**Westinghouse
Electric Corporation**

July 20, 1992

Subject: Additional Information Regarding Bloomfield, NJ Facility

Your letter dated June 18, 1992 contained thirteen (13) items requesting additional information necessary for your office to complete its review for final NRC clearance relative to the radiological cleanup of Buildings 1-6 at our closed Bloomfield, NJ lamp manufacturing facility. Following are our responses to your requests by item:

Figure 2
WELL LOCATION MAP

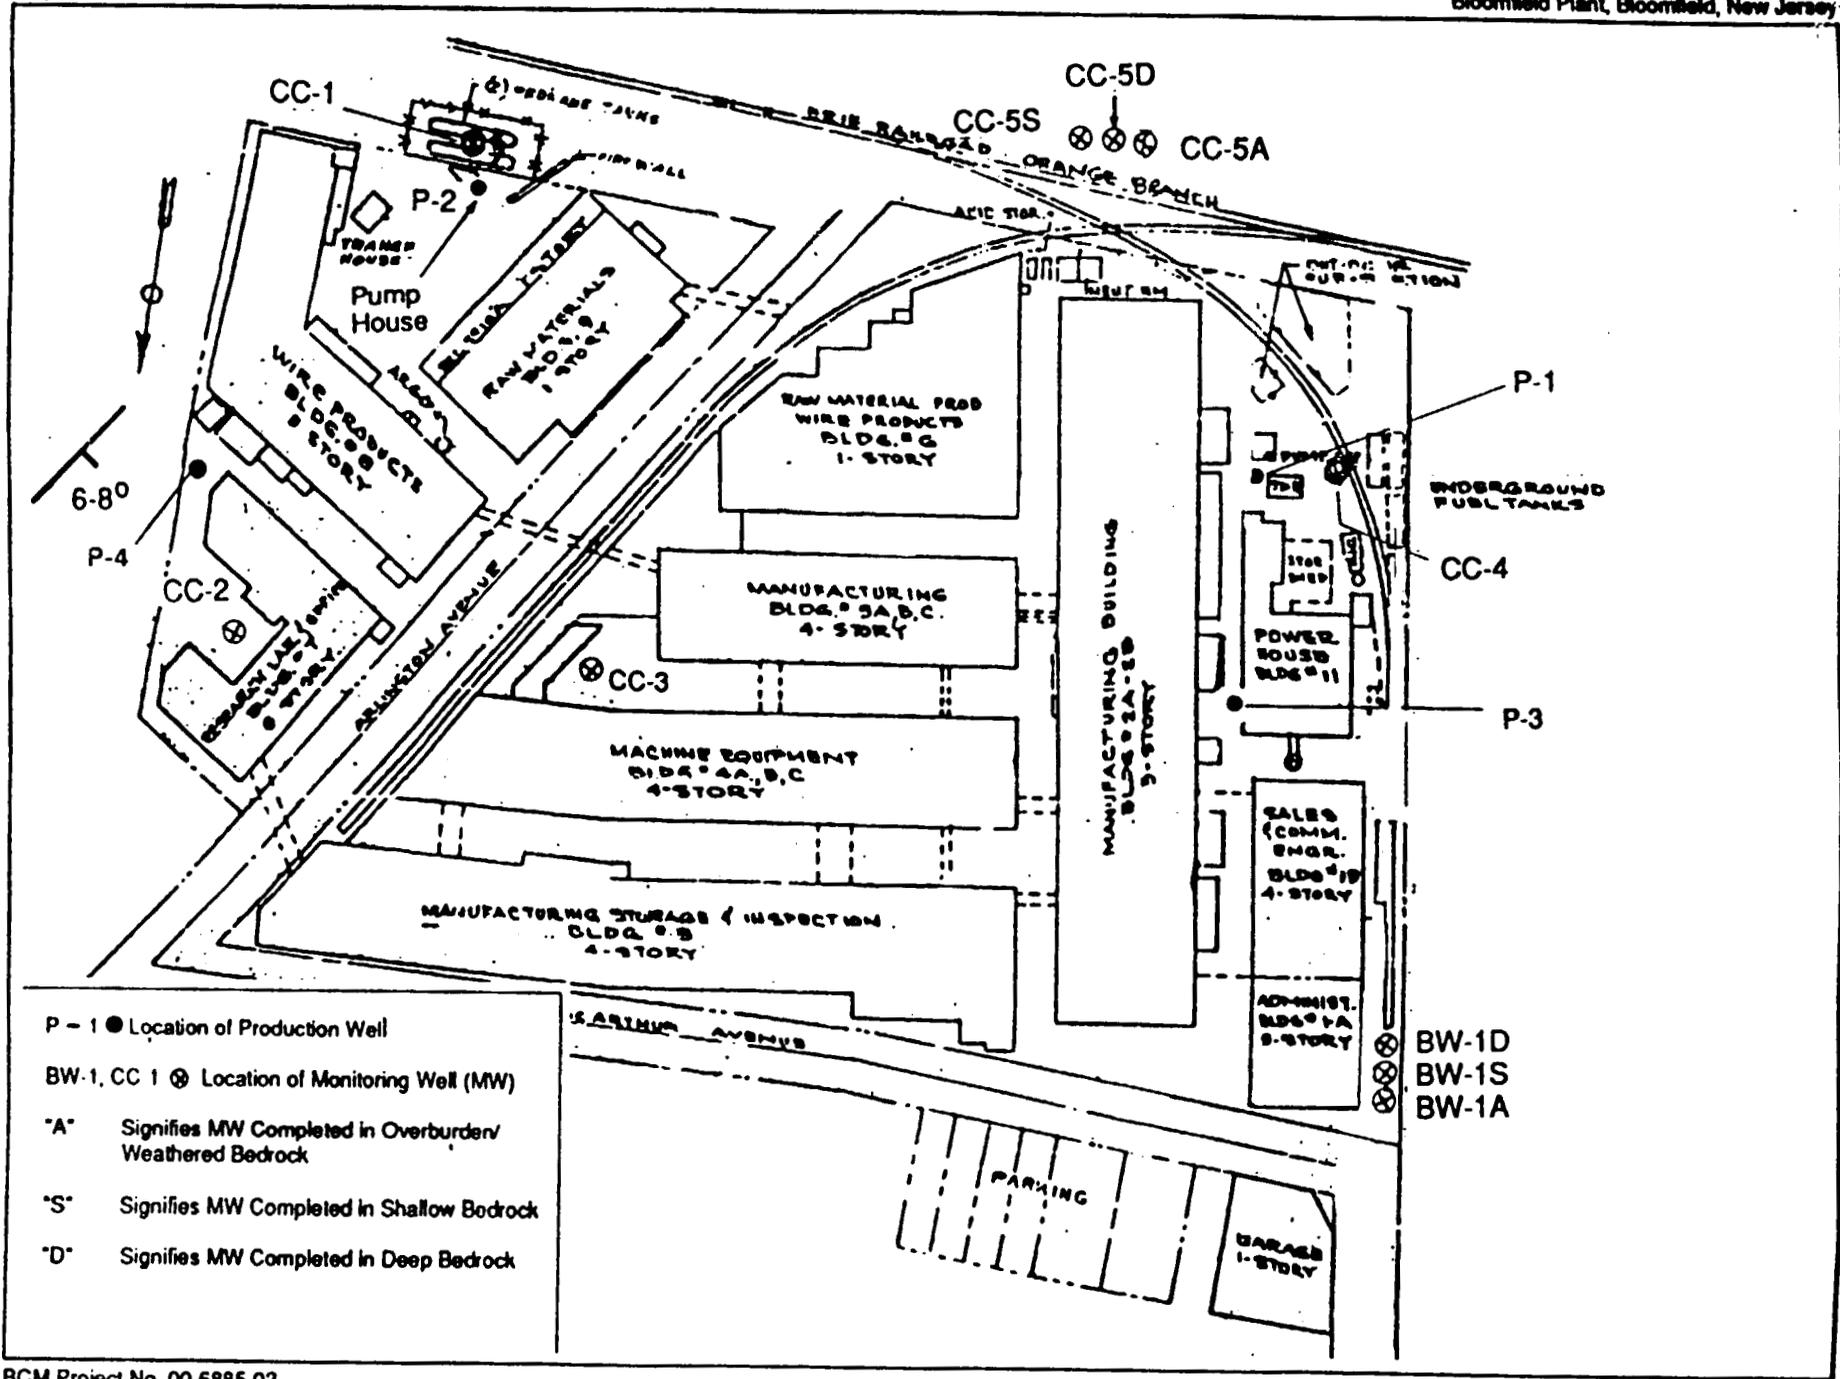
In your September 23, 1991 response to our letter of April 29, 1991, you provided two tables of results of analyses of ground water samples. Please provide a map or diagram of the locations of the monitoring wells from which these samples were obtained, the dates the samples were obtained and the depth where each of the samples was obtained.

Ground water samples from 2 overburden (regolith) and 7 bedrock wells at the Bloomfield site collected on May 23, 1990 were analyzed for radioactivity and select radionuclides. The results of this testing are given in the enclosed Table 11. In addition, samples from

production wells P-2, P-3, and P-4 were collected on March 11, 1986 and analyzed for gross alpha activity, total uranium activity, and total uranium concentration. These data are presented in Table 1.

The locations of all these wells are shown in the enclosed Figure 2. Wells construction data indicating the depths from which these ground water samples were collected are given in the enclosed Table 6.
